**RE: Adequacy Review, 112 Construction Materials Amendment AM4; Hayden Gravel Pit, DRMS File No. M-1987-164**

**Re: Hayden Gravel Pit – Permit No. M-1987-164; Amendment 4 (AM-4)  
Exhibit G and Rule 6.5 – Preliminary Adequacy Review**

*Figure 1: Reclamation Map F-1 for the Hayden Gravel Pit which depict new permit boundary lines as part of AM4. Red box highlights the portion of the southern boundary line referenced above.*

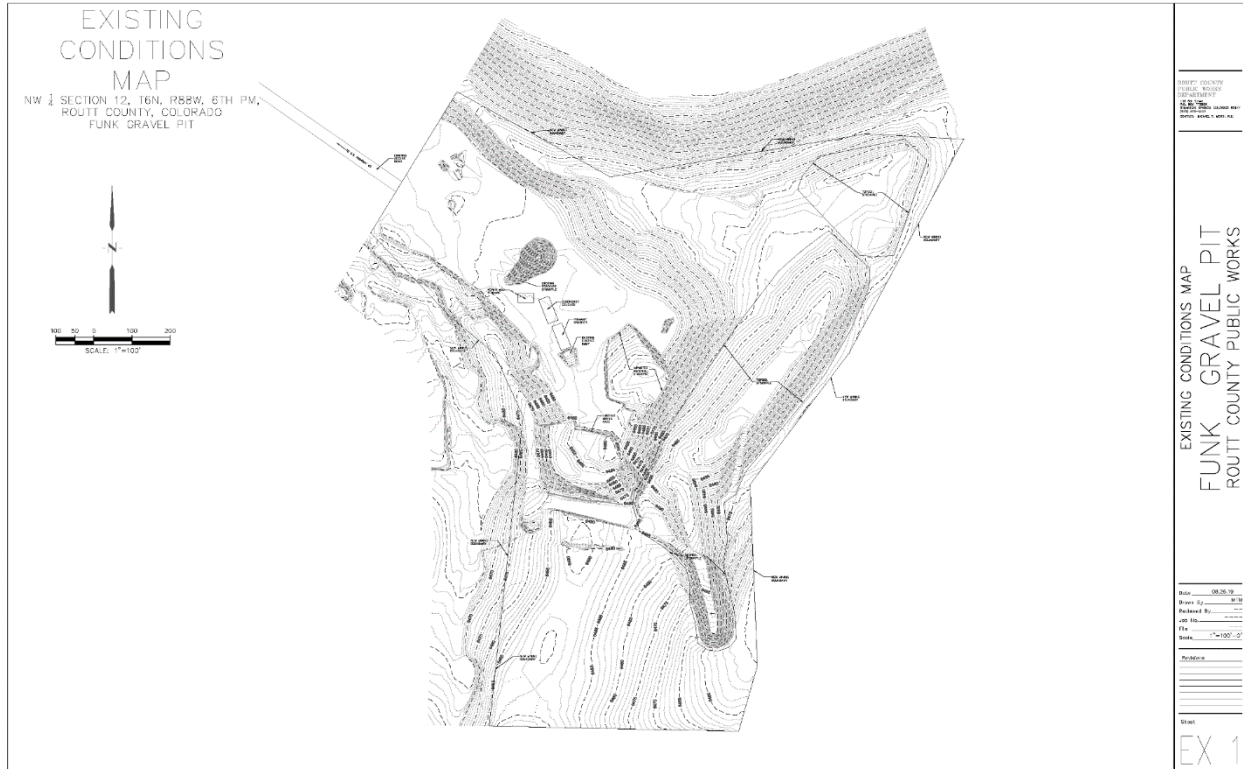
24. The Reclamation Map F-1 and other maps provided depict a southern portion of the proposed permit boundary (Figure 1) which appears to overlap with land which is currently permitted under another DRMS permit (Figure 2) held by Routt County, the Funk and Hooker Pit (M-1979-058). Please clarify if this boundary (Figure 1) is drawn in its intended location. DRMS will not permit over the county's existing permit if this is the case. Please revise all permit boundaries shown on maps to reflect either a corrected or new permit boundary line.
